SAFETY RECALL 073

XLH-FXR UPPER MOUNTING BOLT, FRONT BRAKE CALIPER

Figure 1. Front Caliper Mounting

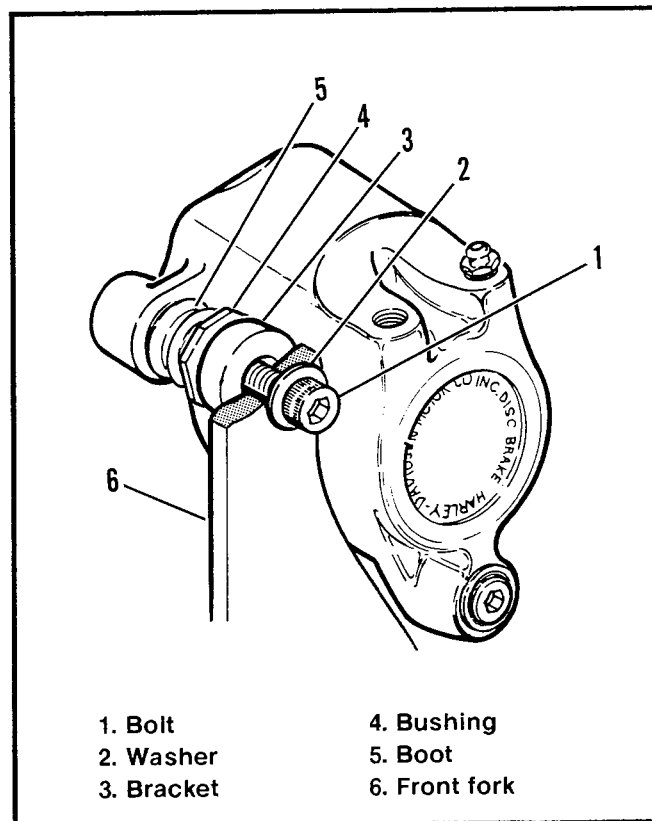
Harley-Davidson has become aware the possibility exists that the upper mounting bolt on the front brake caliper(s) might develop a fracture during normal motorcycle use. Despite the fracture of a mounting bolt, the front brake will remain functional on these motorcycles. If a mounting bolt would fracture, the bolts mating threaded bushing might gradually move out of position and make contact with the spokes of the motorcycle's front wheel. If this condition were to occur, the motorcycle's front wheel might suddenly lock up.

As a precautionary measure, Harley-Davidson recently elected to initiate a voluntary recall in the interest of motor vehicle safety. The potential problem will be remedied by replacing the upper mounting bolt(s) on the potentially affected motorcycles.

1. See Figure 1. Remove upper bolt (1) attaching caliper to fork lug. Save washer (2), for later installation, and bolt (1) for return.

2. Place original washer (2) on new bolt (1), from kit and insert through fork lug (6), bracket (3) and thread into internal threads of bushing (4). Tighten bolt (1) to 25-30 ft-lbs torque. Check front brake to ensure proper operation. If vehicle is equipped with dual caliper brakes, repeat procedure at second caliper.
